molex

Product Change Notification

Date Issued :	June 17, 2022	PCN Number :	511989
Reason for Change :	Change to Product		
Description of Change :	The purpose of this letter is to change Au plating area to improve product quality and production efficiency. So, we can prevent the plating smudging.		
Assessment of Change :	Reliability Test Report/s		
Planned Implementation Date:	December 17, 2022		
Sample Availability Date:	August 05, 2022		
Internal Molex Qualification Date :	June 17, 2022		
Last date to request Samples by Custo	omer: July 15, 2022		
Traceability Code Markings / Date :	Product made after planned implementation date can contain the change

Before Picture

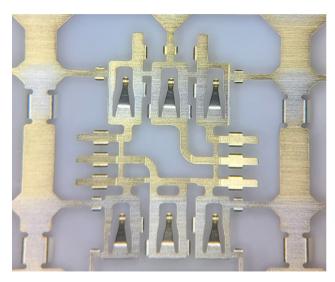
- The purpose of this letter is to change Au plating area to improve product quality and production efficiency. So, we can prevent the plating smudging.
- Product Impact
 - No impact on Fit, Form and Function.
- Part Number Impact
 - Please refer attached impacted part list.
- Molex fully qualify to implement the change.
- Implementation date may be updated due to customer demand and production condition.
